Kiowa Project No. 17066 MARCH, 2019

OVERLOT GRADING & EROSION CONTROL PLAN

TRACT 7 VALLEY GARDEN SUBDIVISION

Markup Summary

| Engineering Colebrating 30 years Engineering Corporation 1604 south 21st Street Colorado Borings, Colorado 80904 (719) 630-7342 | |
|--|--|
| 2 | |

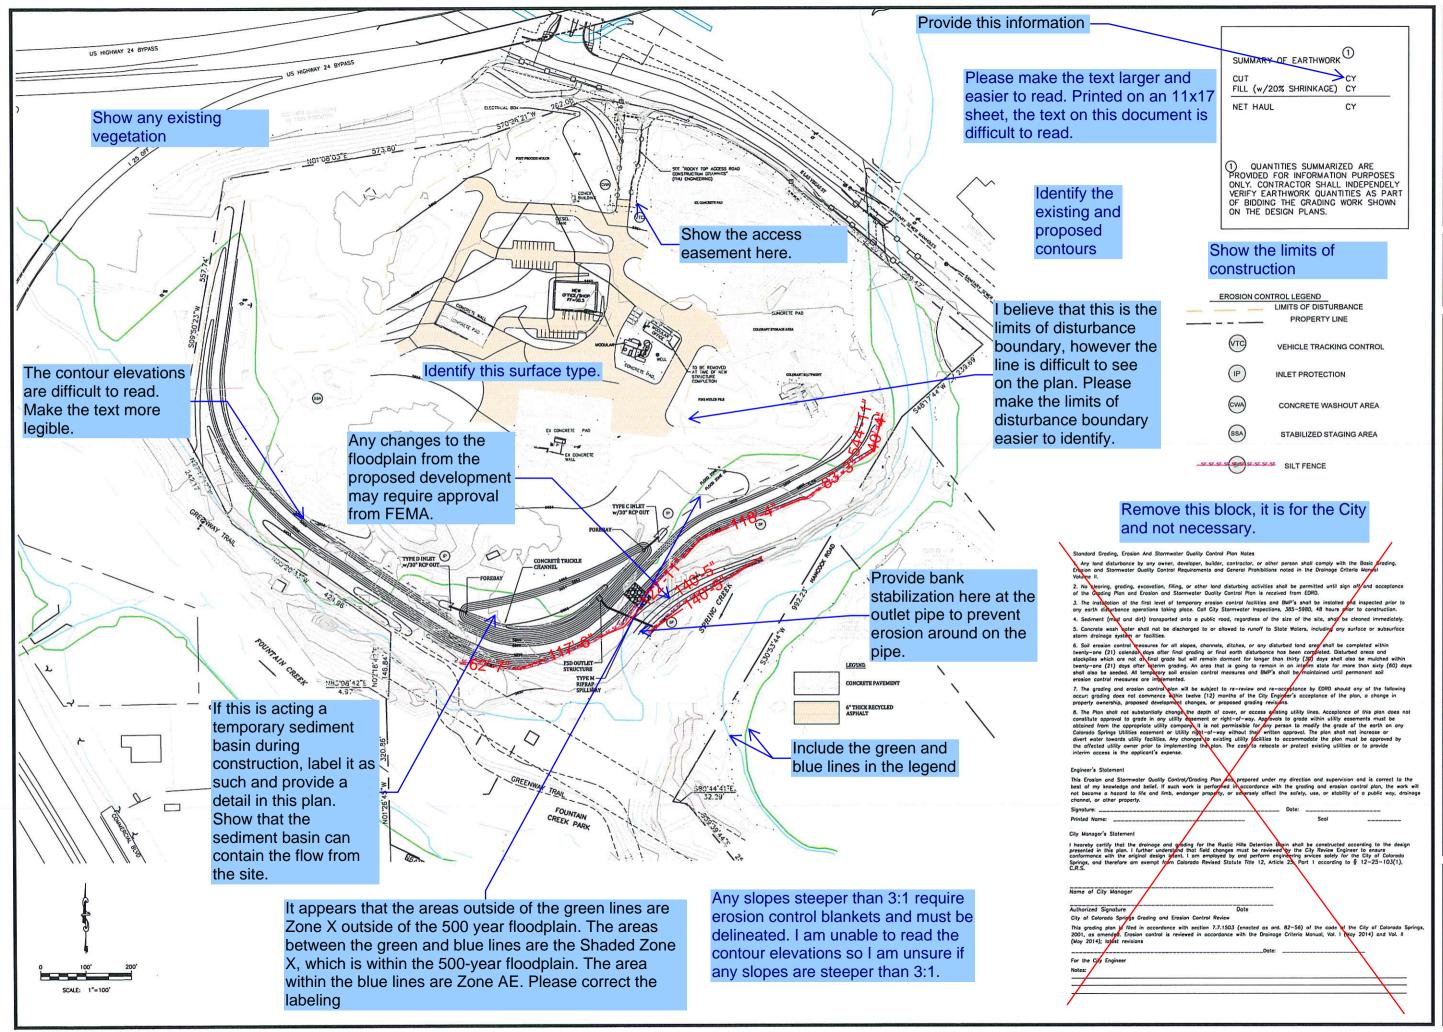
| dsdgrimm (35) | | |
|---|--|--|
| | Subject: Engineer Page Label: 2 Lock: Locked Author: dsdgrimm Date: 4/24/2019 1:40:31 PM Color: | Remove this block, it is for the City and not necessary. |

Identify the

existing and

proposed

contours

Subject: Engineer Please make the text larger and easier to read. Page Label: 2 Printed on an 11x17 sheet, the text on this Lock: Locked document is difficult to read. Author: dsdgrimm Date: 4/24/2019 1:40:32 PM Color: Subject: Engineer Include the green and blue lines in the legend Page Label: 2 Lock: Locked Author: dsdgrimm Date: 4/24/2019 1:40:33 PM Color: Subject: Engineer I believe that this is the limits of disturbance Page Label: 2 boundary, however the line is difficult to see on the Lock: Locked plan. Please make the limits of disturbance Author: dsdgrimm boundary easier to identify. Date: 4/24/2019 1:40:40 PM Color: Subject: Engineer Identify the existing and proposed contours Page Label: 2 Lock: Locked Author: dsdgrimm Date: 4/24/2019 1:40:43 PM Color: Subject: Engineer The contour elevations are difficult to read. Make Page Label: 2 the text more legible. Lock: Locked Author: dsdgrimm Date: 4/24/2019 1:40:44 PM Color: Subject: Engineer It appears that the areas outside of the green lines Page Label: 2 are Zone X outside of the 500 year floodplain. The Lock: Locked areas between the green and blue lines are the Author: dsdgrimm Shaded Zone X, which is within the 500-year Date: 4/24/2019 1:40:45 PM floodplain. The area within the blue lines are Zone Color: AE. Please correct the labeling Subject: Engineer Show the limits of construction Page Label: 2 Lock: Locked Author: dsdgrimm Date: 4/24/2019 1:40:48 PM Color: Subject: Engineer Show any existing vegetation Page Label: 2

Subject: Engineer Page Label: 2 Lock: Locked Author: dsdgrimm Date: 4/24/2019 1:40:53 PM Color: ■ Any slopes steeper than 3:1 require erosion control blankets and must be delineated. I am unable to read the contour elevations so I am unsure if any slopes are steeper than 3:1.

Show the access easement here.

Provide bank stabilization here at the outlet pipe to prevent erosion around on the pipe.

Any changes to the floodplain from the proposed development may require approval from FEMA.

Provide this information

Identify this surface type.

| A Constant of the second secon | Subject: Engineer Page Label: 2 Lock: Locked Author: dsdgrimm Date: 4/24/2019 1:40:59 PM Color: | If this is acting a temporary sediment basin during construction, label it as such and provide a detail in this plan. Show that the sediment basin can contain the flow from the site. |

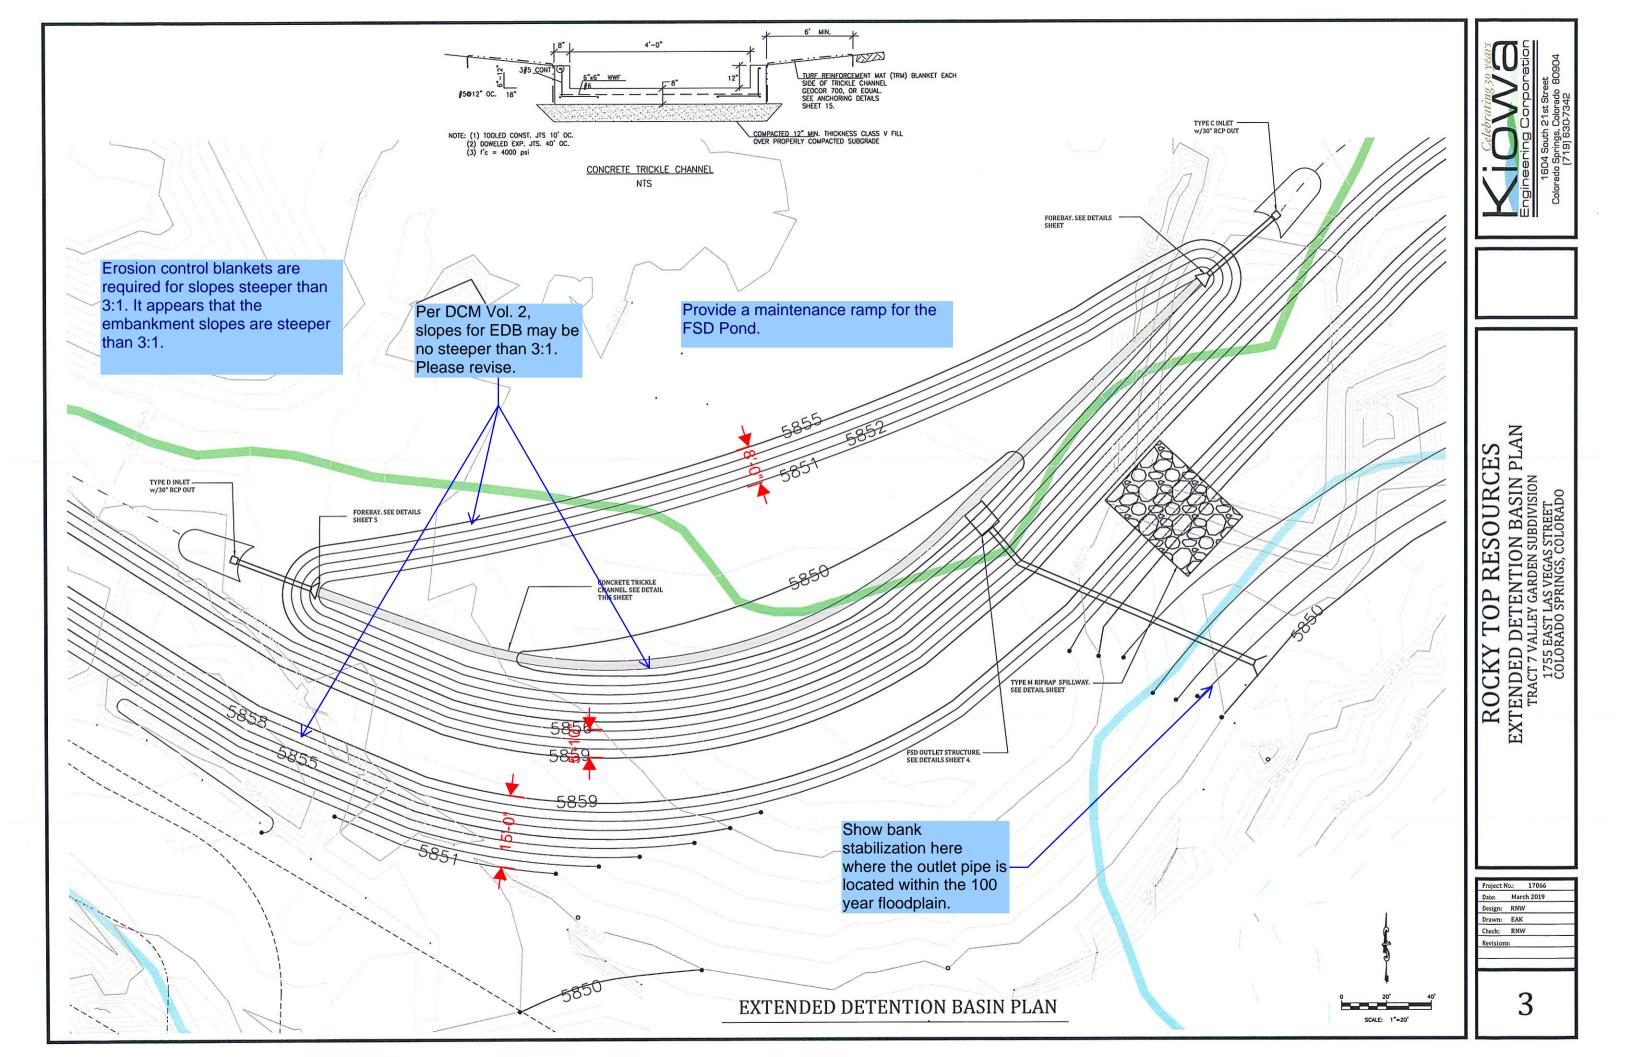
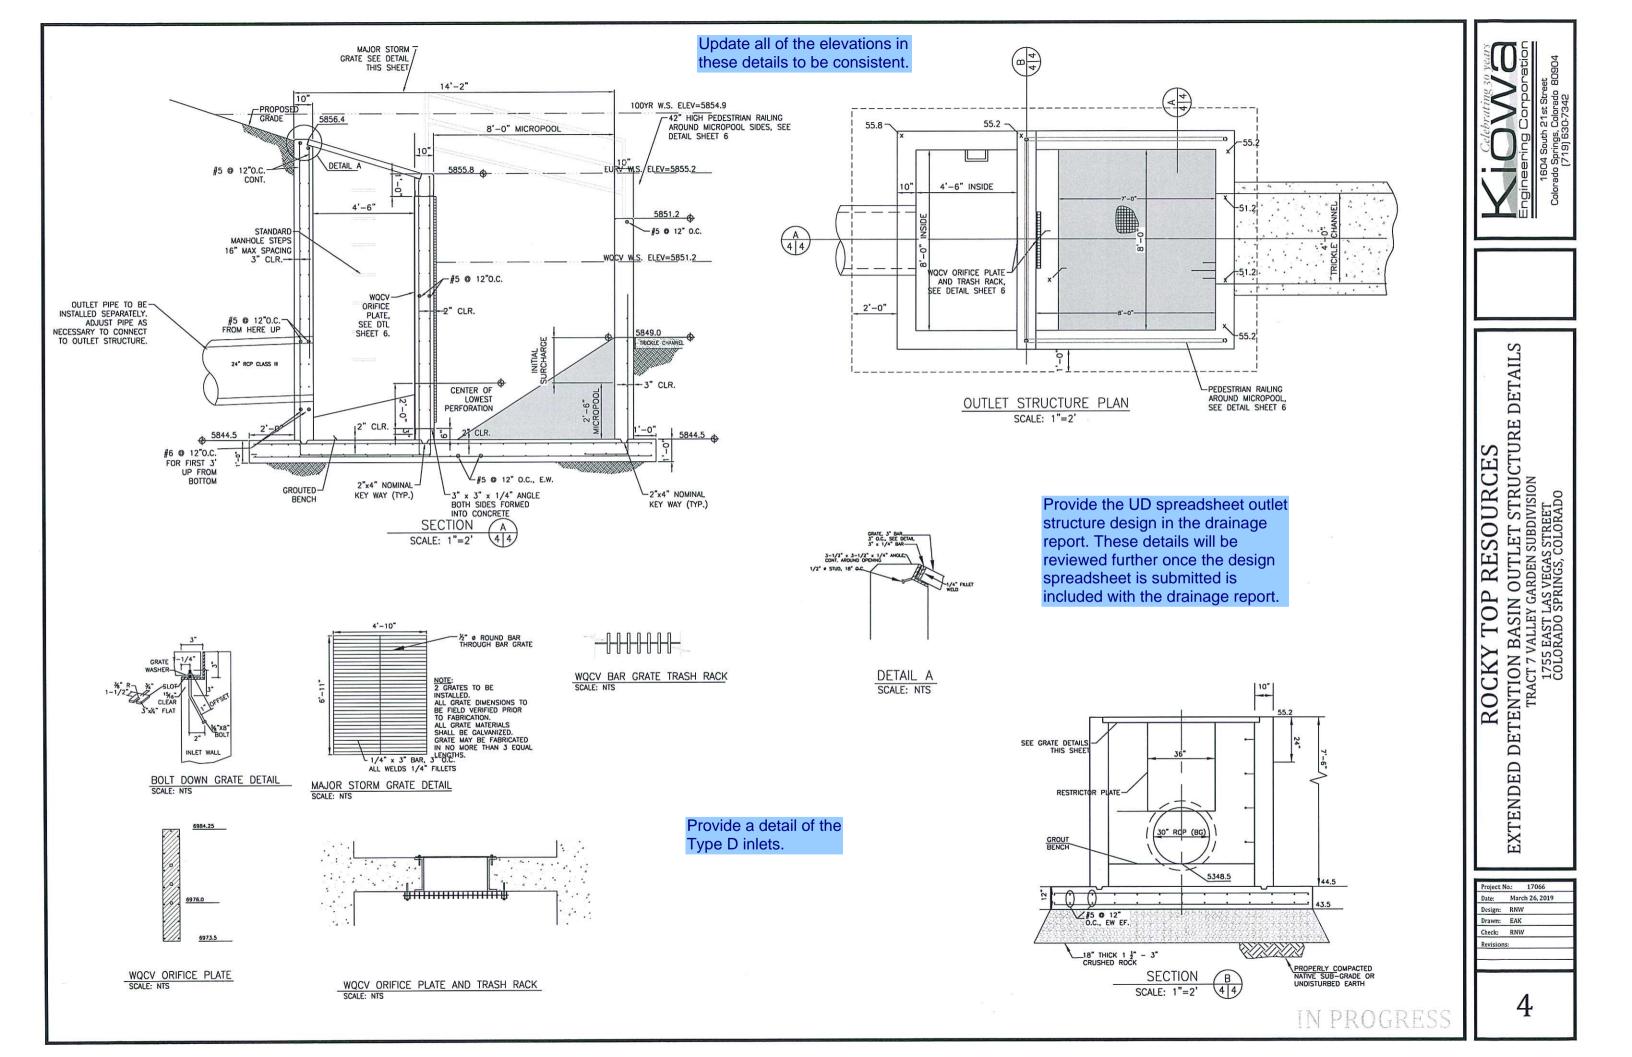
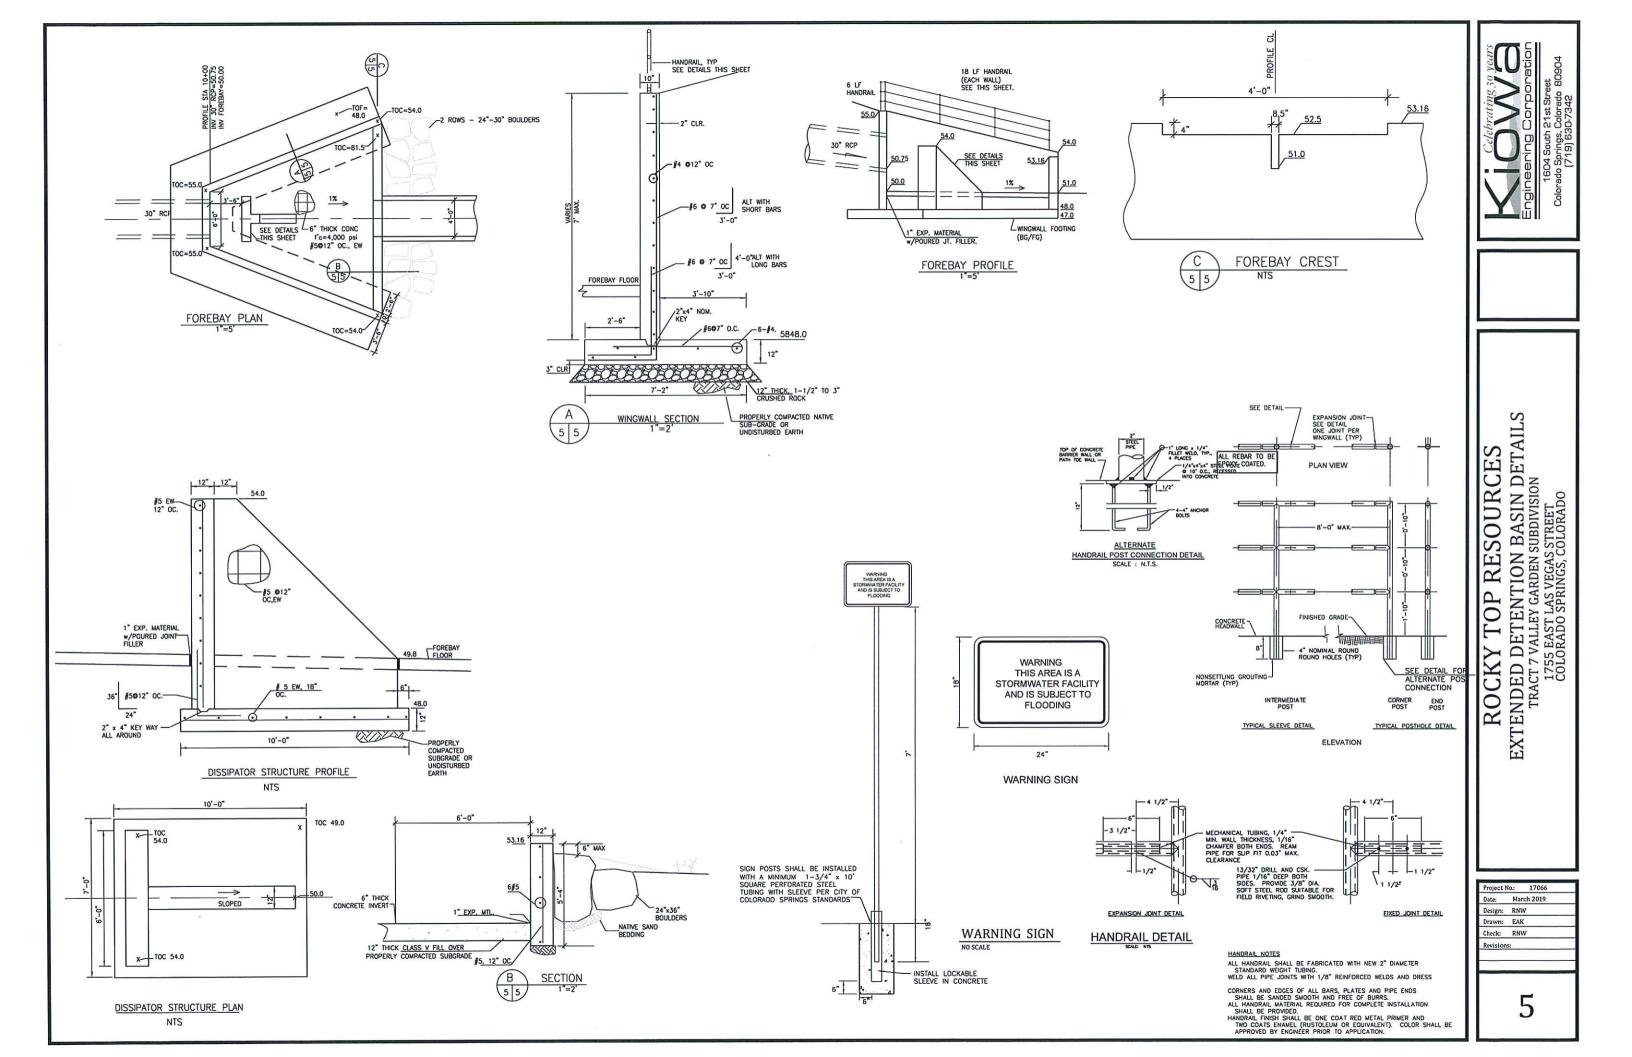
| A Constant of the second secon | Subject: Engineer Page Label: 2 Lock: Locked Author: dsdgrimm Date: 4/24/2019 1:40:59 PM Color: | If this is acting a temporary sediment basin during construction, label it as such and provide a detail in this plan. Show that the sediment basin can contain the flow from the site. |
|--|--|---|
| The set of | Subject: Engineer Page Label: 3 Lock: Locked Author: dsdgrimm Date: 4/24/2019 1:41:01 PM Color: | Show bank stabilization here where the outlet pipe is located within the 100 year floodplain. |
| Protes a mantenance range for the RSD Hout. | Subject: Engineer Page Label: 3 Lock: Locked Author: dsdgrimm Date: 4/24/2019 1:41:02 PM Color: | Provide a maintenance ramp for the FSD Pond. |
| Ecision control blevkels are required of slopes steeper than 3.1, tappears that the enclosurement slopes are steeper non 3.1. | Subject: Engineer Page Label: 3 Lock: Locked Author: dsdgrimm Date: 4/24/2019 1:41:04 PM Color: | Erosion control blankets are required for slopes steeper than 3:1. It appears that the embankment slopes are steeper than 3:1. |
| | Subject: Engineer Page Label: 3 Lock: Locked Author: dsdgrimm Date: 4/24/2019 1:41:08 PM Color: | Per DCM Vol. 2, slopes for EDB may be no steeper than 3:1. Please revise. |

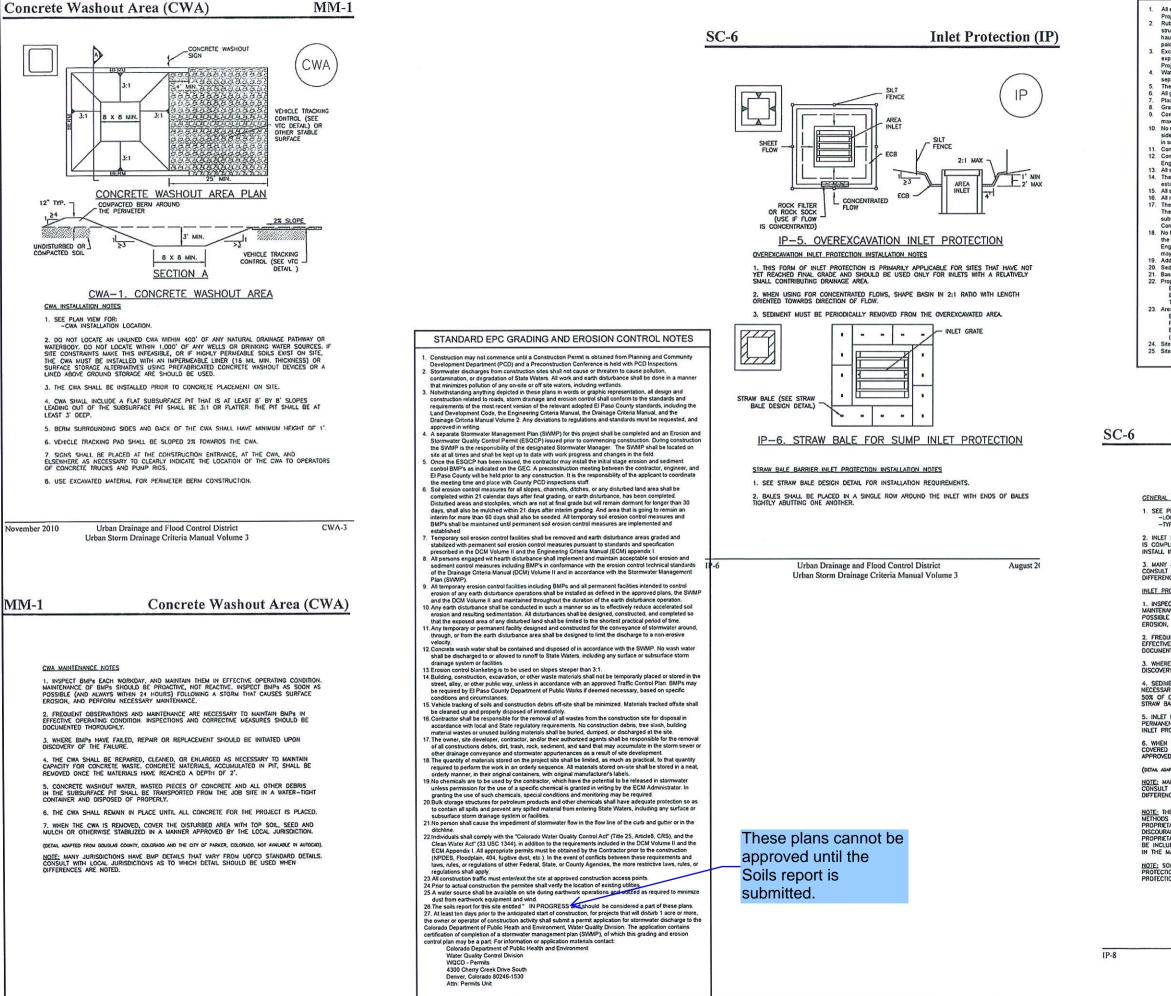
| Privide the LID spendolver curlet abuckure design in the diamage report. These details will be the encoded and the spendol of the spendol spreadheart is submitted a included with the dramage report. | Subject: Engineer Page Label: 4 Lock: Locked Author: dsdgrimm Date: 4/24/2019 1:41:08 PM Color: | Provide the UD spreadsheet outlet structure design in the drainage report. These details will be reviewed further once the design spreadsheet is submitted is included with the drainage report. |
| Update all of the elevations in these details to be consistent. | Subject: Engineer Page Label: 4 Lock: Locked Author: dsdgrimm Date: 4/24/2019 1:41:10 PM Color: | Update all of the elevations in these details to be consistent. |
| Provide a detail of the Type D inlets. | Subject: Engineer Page Label: 4 Lock: Locked Author: dsdgrimm Date: 4/24/2019 1:41:12 PM Color: | Provide a detail of the Type D inlets. |
